Re: **Hudbay Copper World Project Update**

Re: **Copper World Operations; Aquifer Protection Permit No. 513690, LTF 90620**

Copper World Aquifer Protection Permit: Pima County Staff Comments

FIGURE 16-7: SECTION A-A' – EAST PIT MINE PHASES

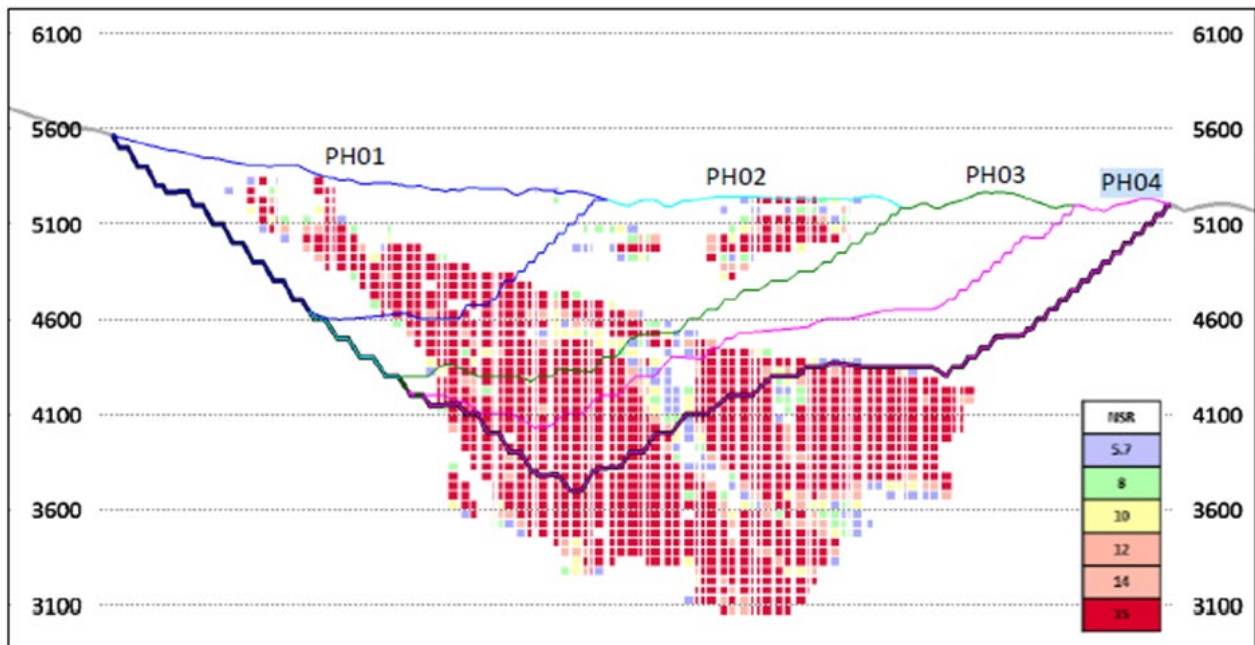
2. Pima County believes that it is intentionally and inappropriately misleading to say this is a permit for a 15-year project, when the actual term of the permit is valid until suspended or revoked by ADEQ. The entire Copper World project has an extended 30+ year Phase 2 to begin once Hudbay can acquire the necessary federal permits that have so far impeded their progress towards permitting of the original Rosemont Copper project. While a two-phased

approach was presented in the 2022 Preliminary Economic Analysis (PEA), their 2023 PFS claims that Hudbay has redesigned their plan into a single 20-year plan with four smaller phases. However, the APP application discusses a mine life of 15 years, indicating that their plan is once again for this Phase 1 and Phase 2 as presented in the PEA. The figure below is from Section 16.2.3.2 of the PFS and although Hudbay claims that the bold purple line represents their final phase of their 20-year mine life, it is clear and obvious that they are simply positioning the pit to go back and process the remaining ore body as modeled by red. It is difficult to believe that Hudbay will do all this work, construct these facilities, and then leave the remaining ore body unmined. As mentioned earlier, the only reason they cannot do it from the beginning is because their resultant pit would be too wide and the extra waste would need to be deposited onto federal lands. The private lands they currently hold are not large enough for the waste material. In granting the permit, ADEQ should acknowledge to the public that this permit, as amended, could be active for at least 45 years.

3. Pima County requests the addition of the East Pit as an APP-regulated facility under the Copper World permit. ADEQ is obligated to evaluate whether or not the East pit is a discharging facility under A.R.S. §49-241.A. It is claimed in the application and supported by studies that the Rosemont Pit will eventually become a hydraulic sink, and is therefore not a discharging facility. However, this behavior of hydraulic sink will take time to establish. During initial pit construction and operation, the pit may not act as a hydraulic sink. The applicant has not demonstrated that the discharged pollutants will be captured and hydrologically isolated in the depressed water table around the pit at early timeframes. Additionally, the use of the dewatering volume used to maintain the hydraulic sink during closure and post-closure have not been addressed.

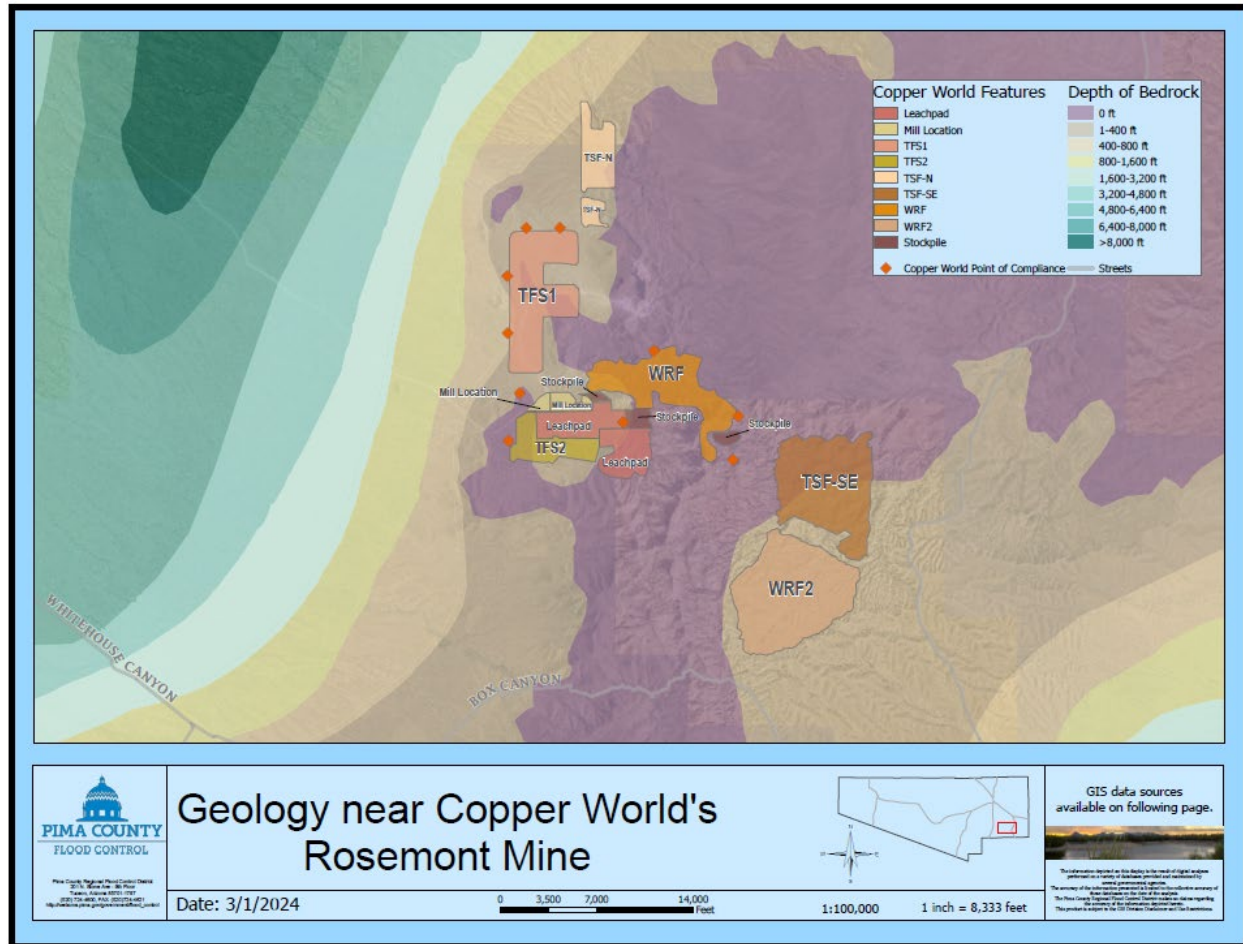
28. The TSFs and associated seepage collection system must be lined. We offer two supporting reasons: 1) Hudbay's individual BADCT justification is based on inaccurate site descriptions. The suggestion that the groundwater is limited and discontinuous and that there is no appreciable groundwater flow or travel over distances is proven false by Figure 70-1 from Attachment 31 of Hudbay's response to ADEQ's initial Request for Additional Information (RAI). 2) It is inappropriate for ADEQ to approve an individual BADCT plan for the TSFs that is less protective than the prescriptive BADCT. It is clear that lining the TSFs is more protective of the aquifer. Text below provides more detail on the flawed justifications for individual BADCT.

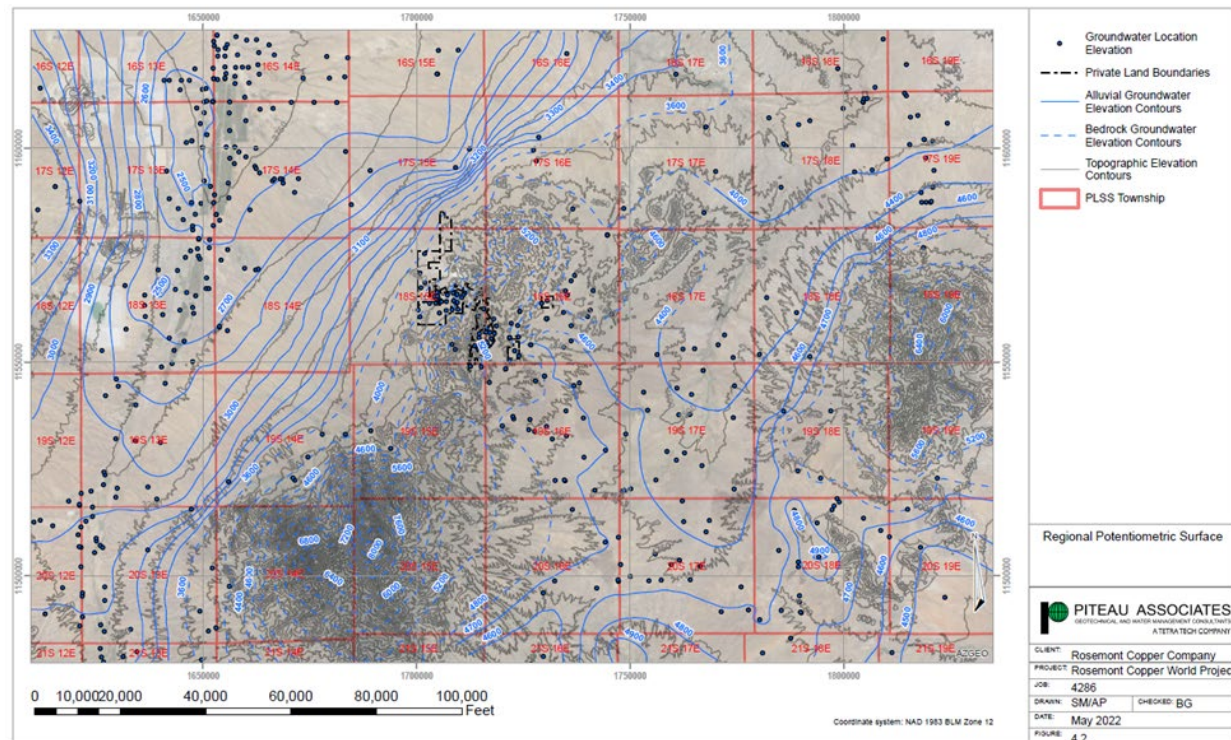
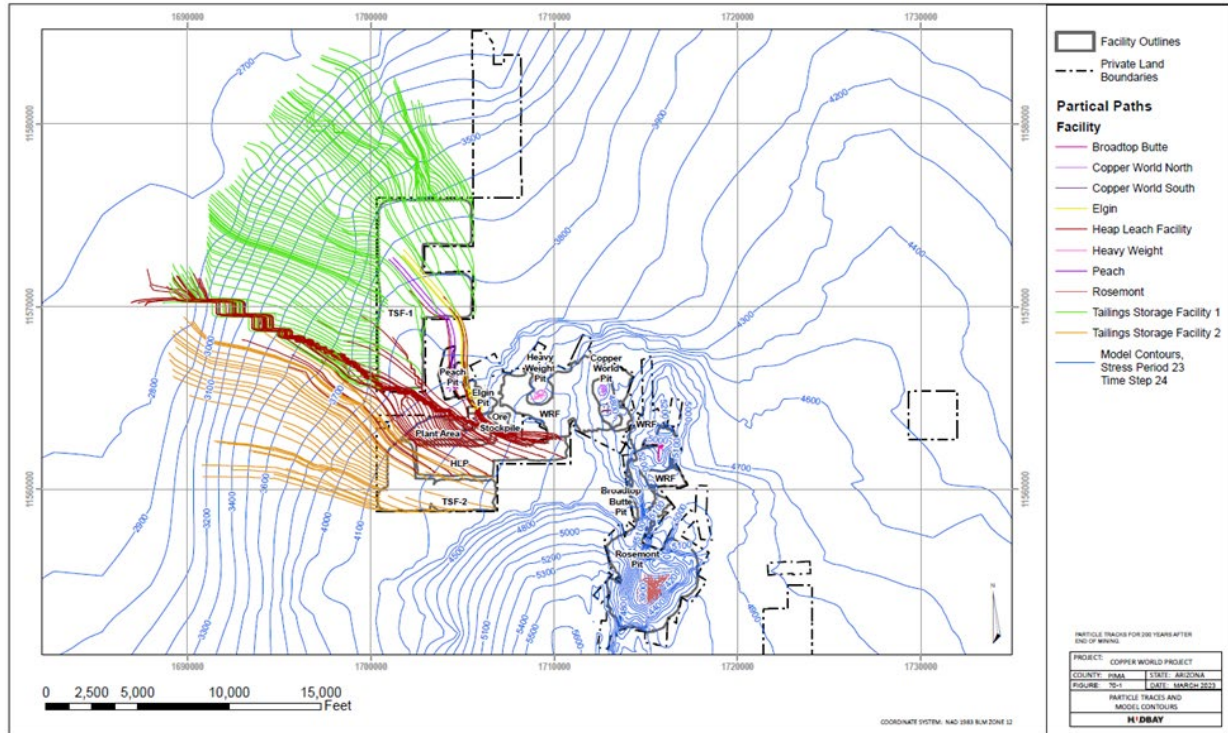
The figure below provided by Pima County Regional Flood Control District shows the depth to bedrock. There is a large drop off in the bed rock which goes to 400-800 feet. This demonstrates the varied site conditions and the possibility for leakage through the bedrock and directly into the aquifer. The site-specific conditions given in the draft permit are inappropriate and are inadequate in managing pollution in the TSFs.

The particle traces and groundwater model contours as displayed in Figure 70-1 (below) from Attachment 31 of Hudbay's response to ADEQ's initial RAI is useful in demonstrating the hydraulic gradient and the mobility of pollutants discharged at certain points within the PMA. Not only does this figure demonstrate a clear hydraulic gradient to the northwest of the TSFs with the blue contour lines, but it also confirms via the particle traces (in red and green) that there is significant pollutant mobility for the TSFs and the HLP. The hydraulic gradient is again confirmed by Figure 4.2 (below) of Appendix F.1.

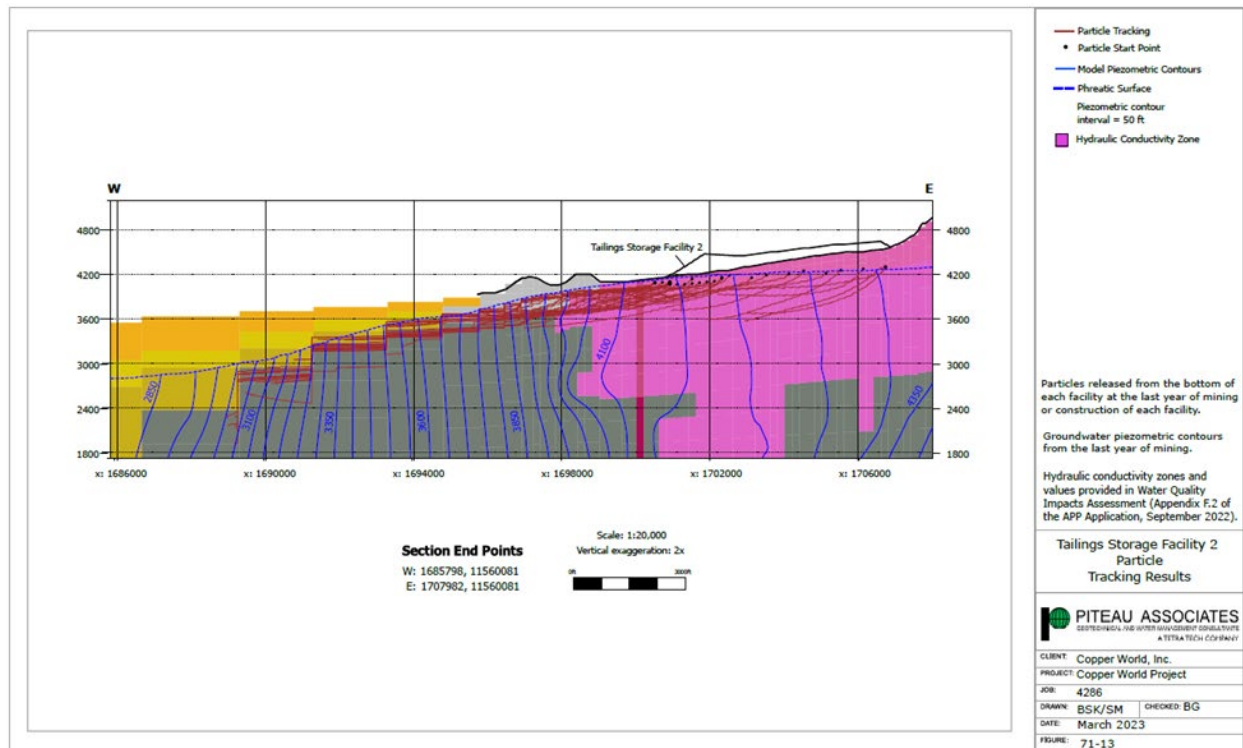
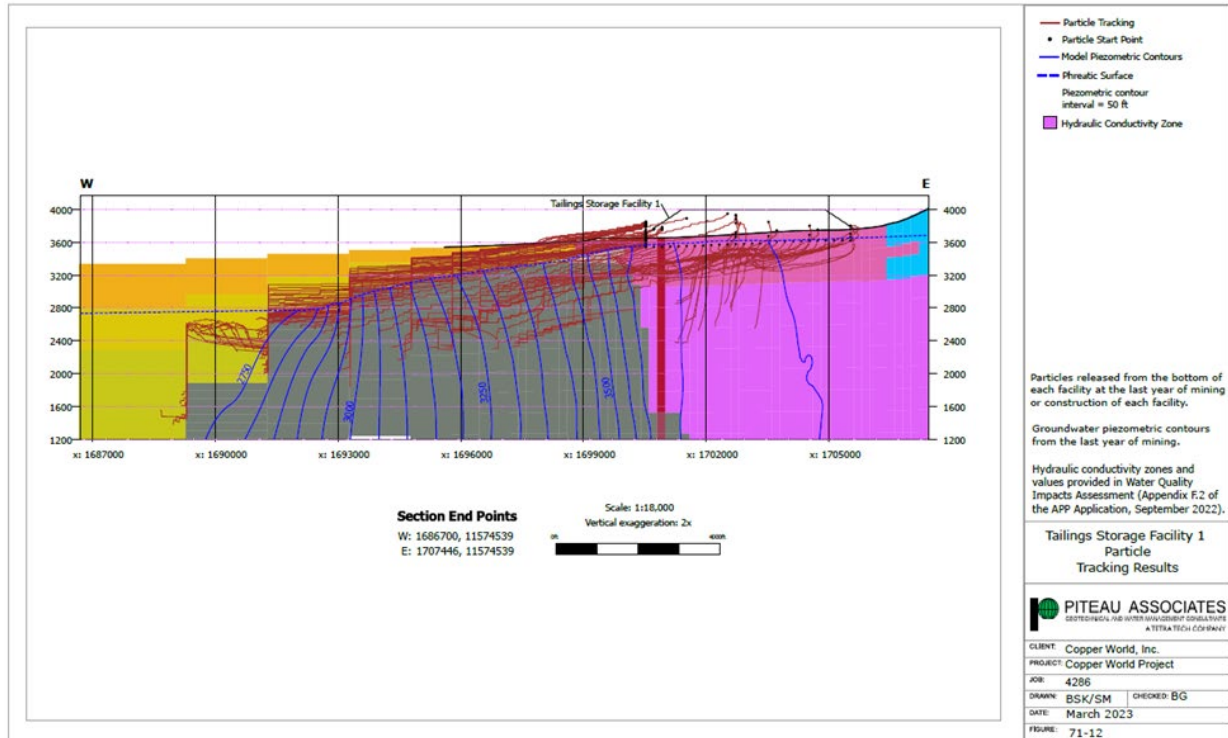
Additionally, Figures 71-12 and 71-13 (below) from Attachment 32 to Hudbay's response to ADEQ's initial RAI show the cross-sectional particle traces for TSF-1 and TSF-2, respectively, and further demonstrate the high mobility of pollutants downward and laterally. In the traces

below, the model shows pollutants moving down and through the alluvium unit towards the Tucson Basin aquifer. The dashed line in these documents is the phreatic surface, and it represents the depth to water. When a particle tracking line has passed below the phreatic surface, it has effectively entered the aquifer. This should be no surprise, as it was previously stated that the depth to water above the TSFs is only 20 to 48 feet. It can be seen that particle tracing lines nearly immediately cross the phreatic surface, and thus nearly immediately enter the aquifer. Another potential direction of movement would be in the alluvium just above the bedrock contact until it reaches the adjacent basin fill units. The model did not represent thin alluvial unit which underlies the TSFs, which eliminated any consideration of this potential.
